UNITED STATES PATENT AND TRADEMARK OFFICE

10/524,592

Office Action Summary	Application No. 10/524,592	Applicant(s) BONFANTI ET AL.	
	Examiner GERARD T. HIGGINS	Art Unit 1794

DETAILED ACTION

FIG. 1

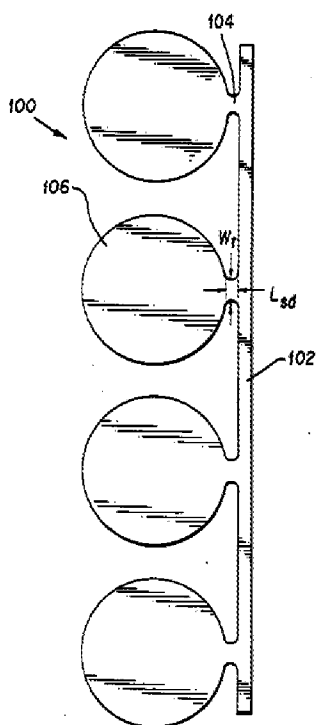
The film of Figure 1 has a dividing line that stretches vertically in between the parts **102** and **106**, which is interrupted by the webs **104**. It is clear from the figure that the webs have a width that is, on average, less than an average spacing between adjacent webs. The parallel dividing lines to which applicants are referring to in claims 24 and 27 would fall in between the parts **106** of Grawey et al., i.e. in the x-direction in Figure 1 above (left-to-right on the paper). Therefore, the mirror plane spoken of in applicants' claim 27 would be in the y-direction (up-and-down) and it clear that performing a reflection about said mirror plane of the device of Figure 1 would generate a device that would not be superimposable. The device of Figure 2 reads on the at least two stamped films superimposed in a staggered arrangement relative to one another of claim 20. Two of the same devices of Figure 1 of Grawey et al. are arranged such that the webs are not superimposed in alternating layers; however, Grawey et al. fail to disclose electrode portions **106** that are square, which would then read on applicants' limitation that the stamped gap has a continuous width across the length of the at least one stamped gap.

With regard to claim 28, it is clear from Figure 1 and 2 that the width of all the webs, respectively, is less than the spacing to said adjacent webs.

With regard to claims 26 and 30, it is clear that a 180° rotation performed on the device of Figure 1 would generate a device that would not be superimposable with the original device.

FIG. 2

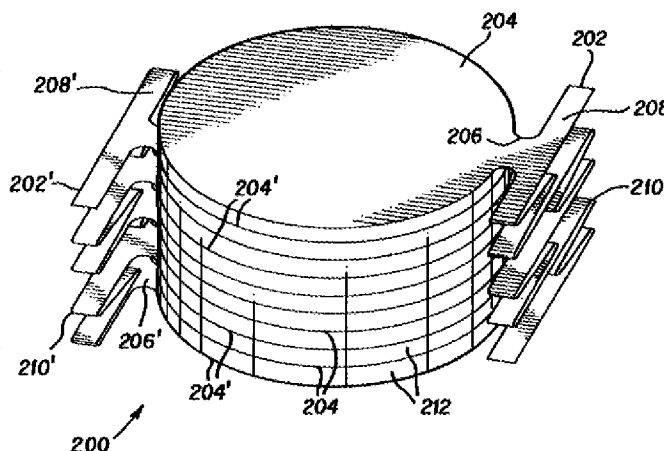
With regard to claim 21, it is clear from Figure 2 that the alternating layers are arranged to differ by 180° of rotation.

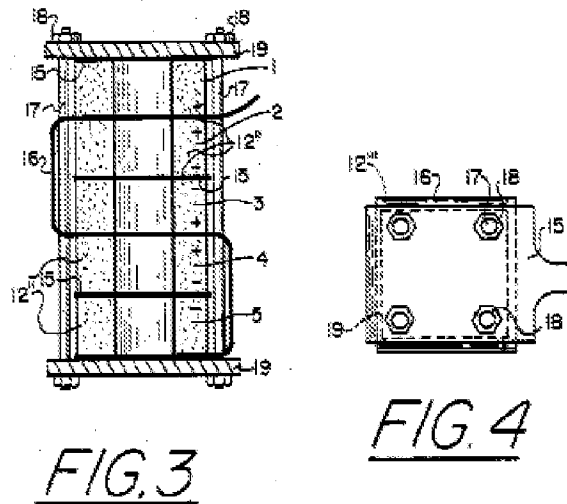
Bechtel et al. disclose the use of transducers in the field of electrochromic automatic dimming rearview mirrors (col.2, lines 22-24).

Both Grawey et al. in view of Mitarai et al. and Bechtel et al. are drawn to transducers, therefore it would have been obvious to one having ordinary skill in the art at the time the invention was made to use the known device of Grawey et al. in view of Mitarai et al. in an electrochromic device such as the one described by Bechtel et al. The combined device would have produced predictable results to one having ordinary skill in the art.

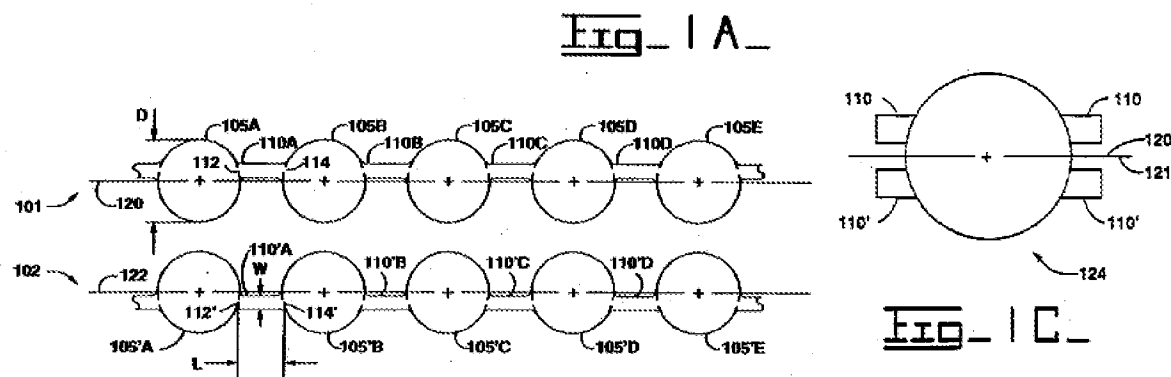
Grawey et al. in view of Mitarai et al. disclose all the limitations of applicants' claim 27 in section 8 above; however, it fails to disclose positioning holes. Abbott discloses the transducer stack seen in Figures 3 and 4.

The transducer stack comprises 2-4 positioning rods **17** (col. 4, lines 3-9), which obviously must have positioning holes for the positioning rod to go through said transducer stack.

Both Grawey et al. in view of Mitarai et al. and Abbott are drawn to transducer assemblies; therefore, it would have been obvious to one having ordinary skill in the art at the time the invention was made to use the known prior art element of positioning holes in the transducer assembly of Grawey et al. in view of Mitarai et al. Each element would have performed the same function as it did separately, and the results of this combination would produce predictable results to one having ordinary skill in the art. The motivation for doing so would be to provide a stable structure that would not wear down or shift position over time.

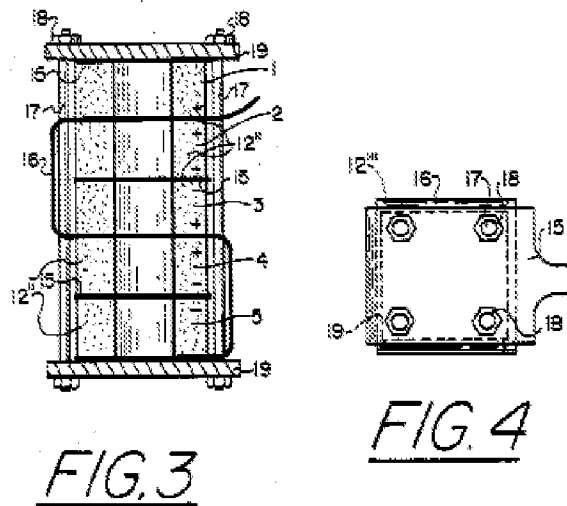
Bechtel et al. disclose the use of transducers in the field of electrochromic automatic dimming rearview mirrors (col.2, lines 22-24).

Both Mitarai et al. in view of Swanson et al. and Bechtel et al. are drawn to transducers, therefore it would have been obvious to one having ordinary skill in the art at the time the invention was made to use the known device of Mitarai et al. in view of Swanson et al. in an electrochromic device such as the one described by Bechtel et al.
